ACCESS PERMIT APPLICATION

Permit # AC2024-05
Parcel ID: H43912

Description of Project: new building lot Is property in floodplain? N

Sketch Plan:

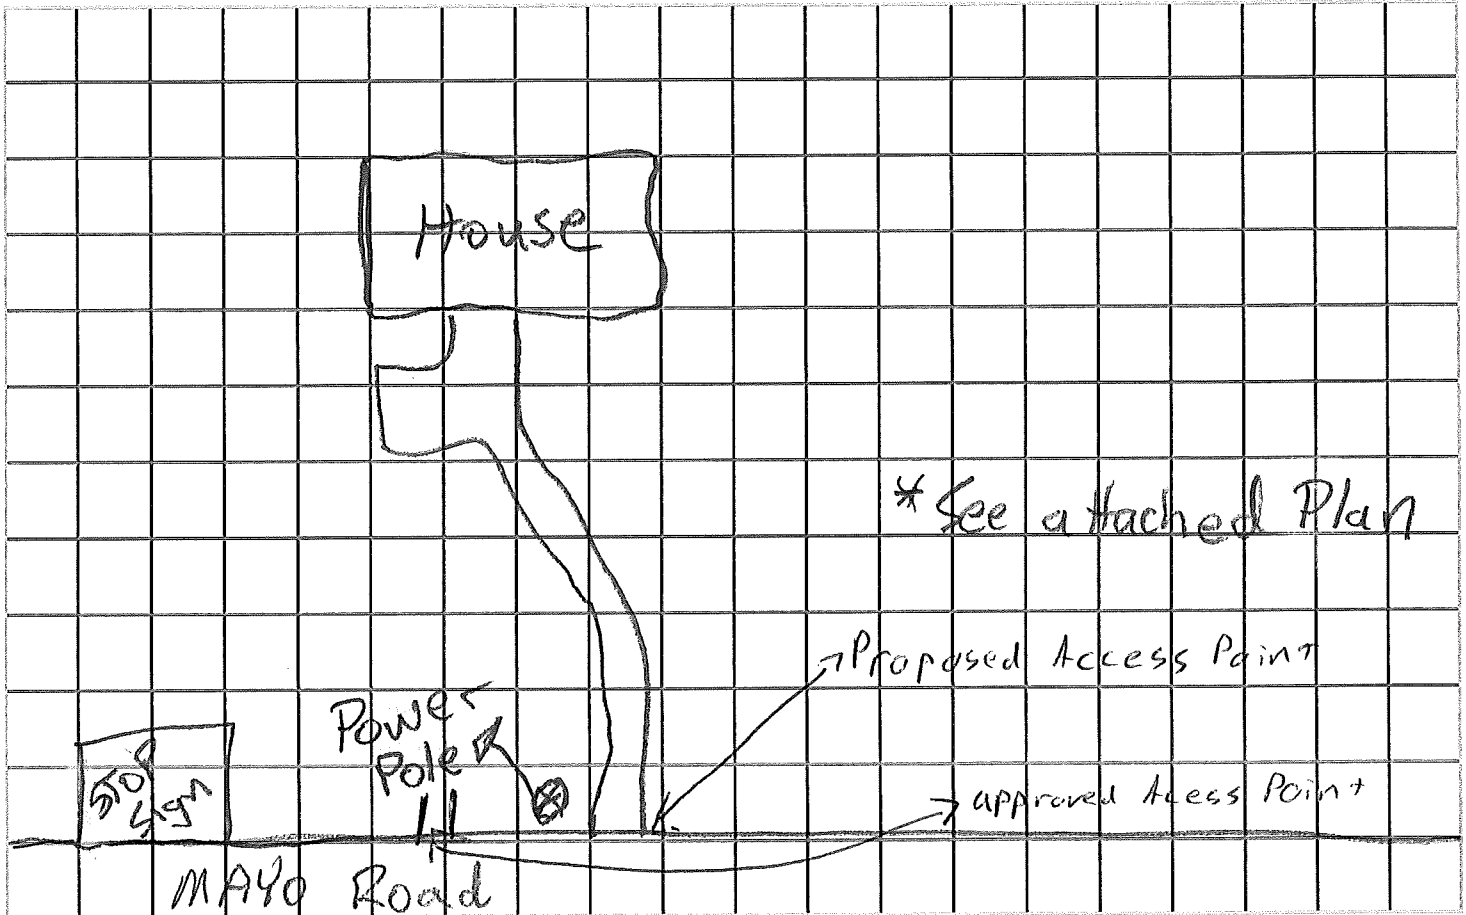
Comments: SIGHTLINE FROM ACCESS COOKING SOUTH EXCEEDS Additional comments on reverse

Highway Department Comments: 285' OK, ACCESS IS 100' FROM HUNTINGTON RD, INTERSECTION OK, INSTALL 12" X 30' HDPE CULVERT PER RICHMOND PUBLIC WORKS STANDARDS. *AS*
